| Intersection ID: 9779 | Main Street: CAMPUS_ST | Cross Street: CEMETERY_ST | Location: | SW |
| ADA ID: 948FD2B791C5 | Ramp Type: PerpDiag | Initial Pass/Fail: Fail | Overall Compliance: No | Severity Score: 35 |

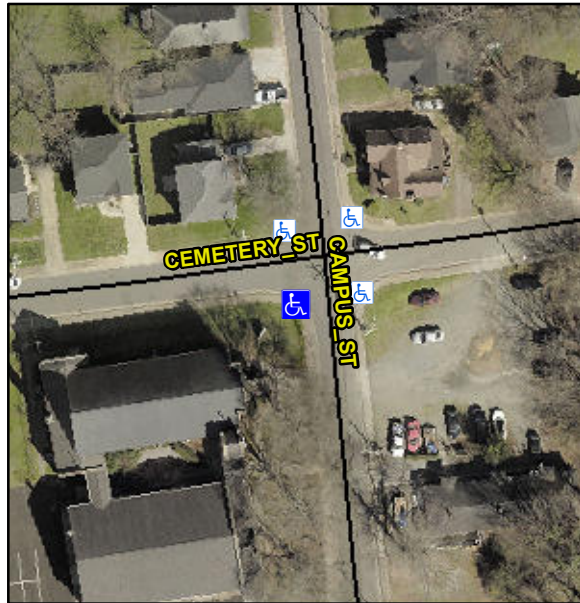
**Not Found, R304.5.1, R304.2.2,
R304.5.3**

| Compliance | Description | Data | Compliance | Description | Data |
|------------|-----------------------|------|------------|-----------------------------|------|
| N/A | Ramp Length (in) | 47.0 | No | Ramp Slope (%) | 12.4 |
| No | Ramp Width (in) | 40.0 | No | Ramp XSlope (%) | 2.2 |

Remove & Replace Curb Ramp With Two New Directional Ramps or Equivalent.
